LP Hose Routing			
Classification		Parts Kit Required			
Recall # 206		Part #	NA	Description	NA
Condition					
On certain Winnebago vehicles, the LP hose may have been incorrectly routed over (rather than behind) the exhaust heat shield.					
Correction					
Inspect the LP hose is correctly routed behind the heat shield. If inspection indicates the LP hose is not correctly routed behind the heat shield, do NOT submit a claim and contact Tech service at techservice@wgo.net					
WGO Model Year	Revision	Make	Model	Model Code(s) (Floorplan)	WGO Built/Manufacturing Dates Impacted
2026	2	Winnebago	Solis	BUT36A, BUT59P, BUT59PX	12/16/2025 – 4/3/2026
2027	1				
Disclaimer: Read the entire instructions carefully before starting the procedure. If you have any questions, please contact the Winnebago Industries Technical Service Department by calling 1-866-653-4329 or by email: techservice@wgo.net . This document is confidential and is intended for dealer use only.

Incorrect Routing

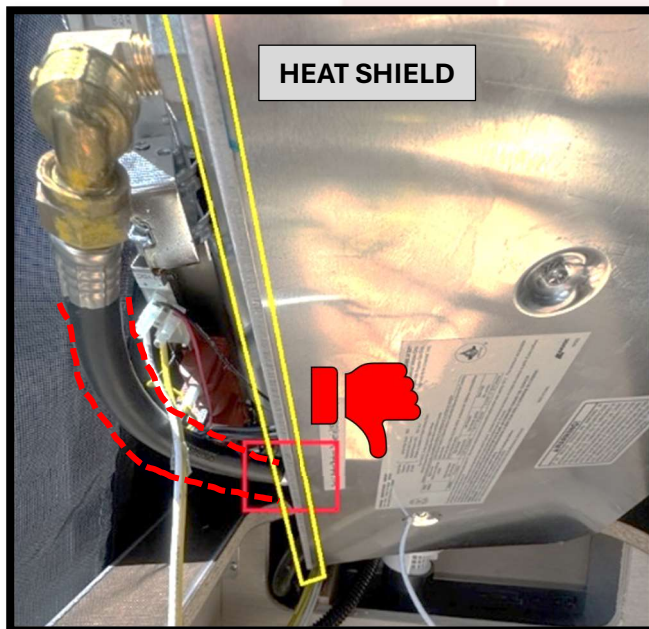
LP hose routed **over the top** of the stove heat shield. The heat shield edge is marked in Yellow, and the hose is marked in red. See image bellow.

LP hose routed **underneath** the heat shield (NOT OVER IT) . The hose is marked green. See image bellow.
